C/CAG APPLICATION FOR LAND USE CONSISTENCY DETERMINATION

AGENCY NAME: City of South San Francisco

PROJECT NAME/ADDRESS: Genesis Station 121 East Grand Avenue

Subject: Application for Land Use Consistency Determination for New Research & Development Building at 121 East Grand Avenue, South San Francisco

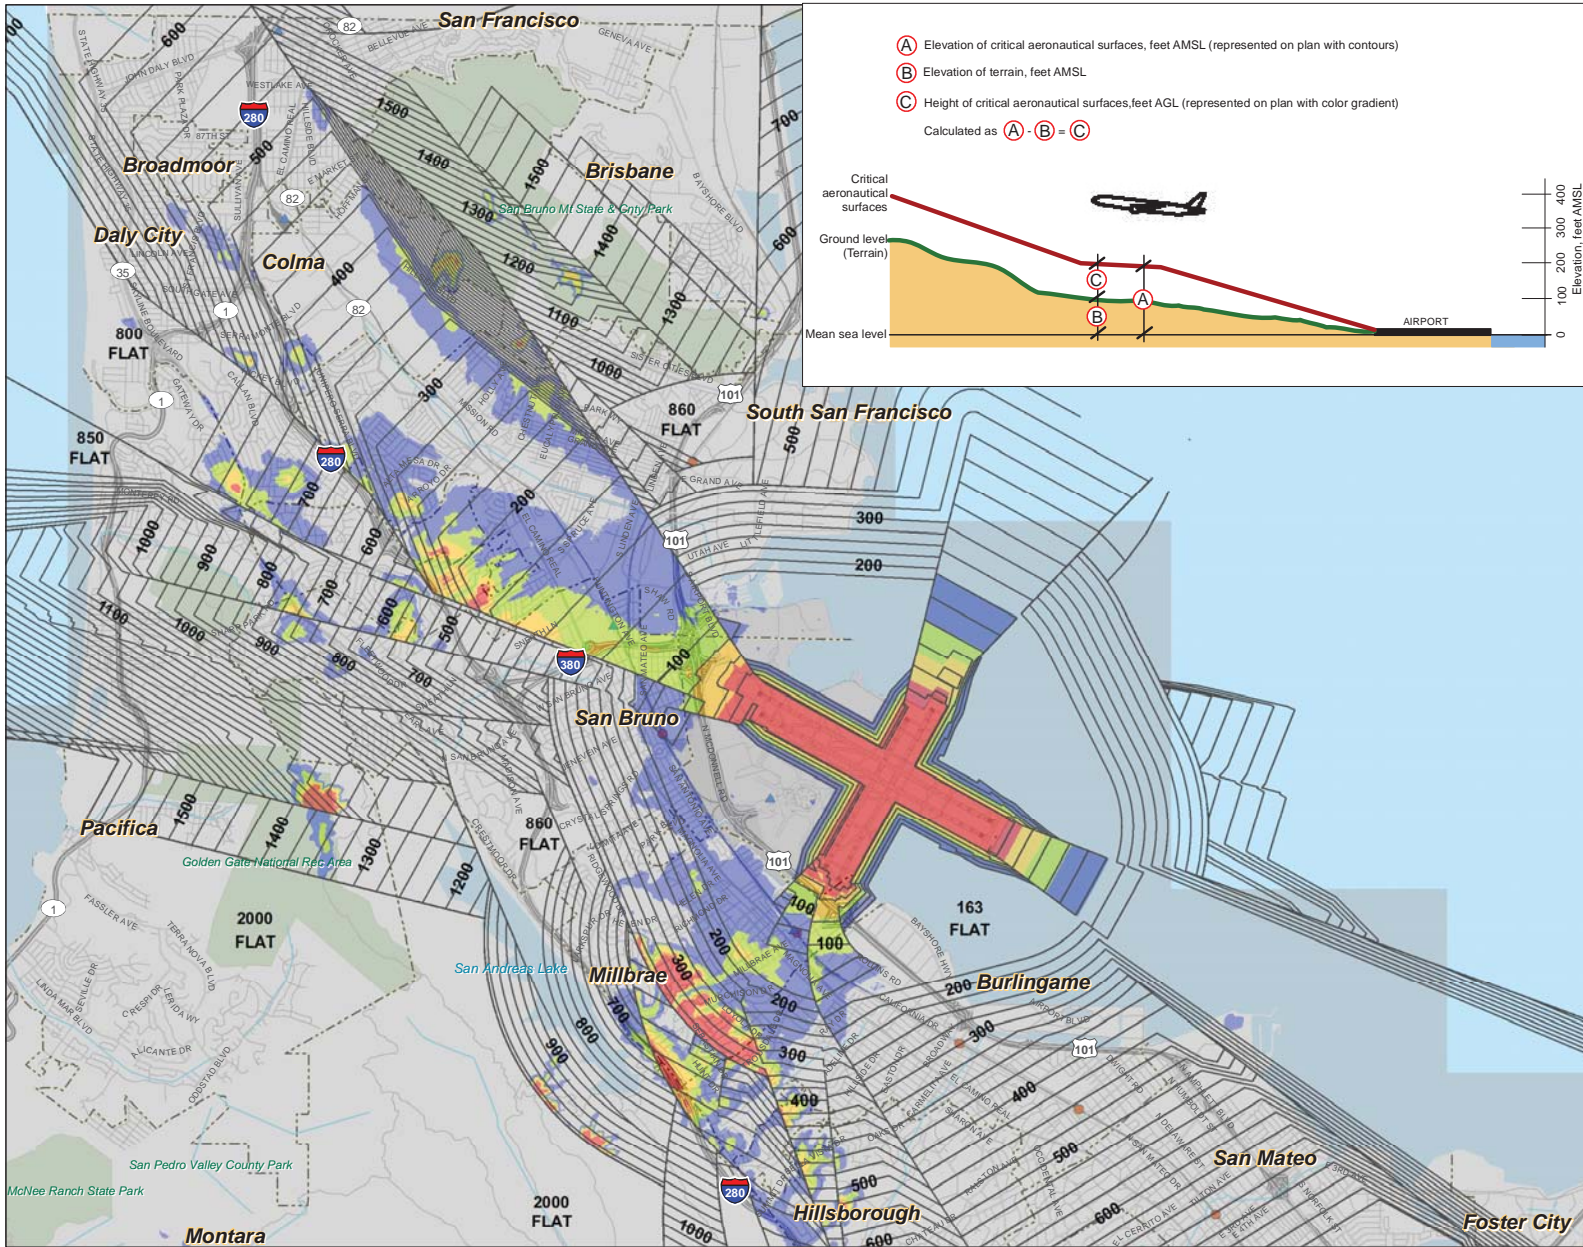
As depicted on Exhibit IV-17 of the SFO ALUCP (see Attachment), the lowest critical aeronautical surfaces above the Proposed Project are at an elevation of approximately 700 feet above mean sea level (AMSL) as defined from the origin of the North American Vertical Datum of 1988 (NAVD88). Given that the ground elevation at the Proposed Project site is around 16 feet AMSL (NAVD88), the maximum height of the building, as currently defined (as 295 feet above ground level), would be below the critical aeronautical surfaces and the Proposed Project would not appear to be incompatible with the Airspace Compatibility Policies of the SFO ALUCP, subject to the issuance of a "Determination of No Hazard" from the Federal
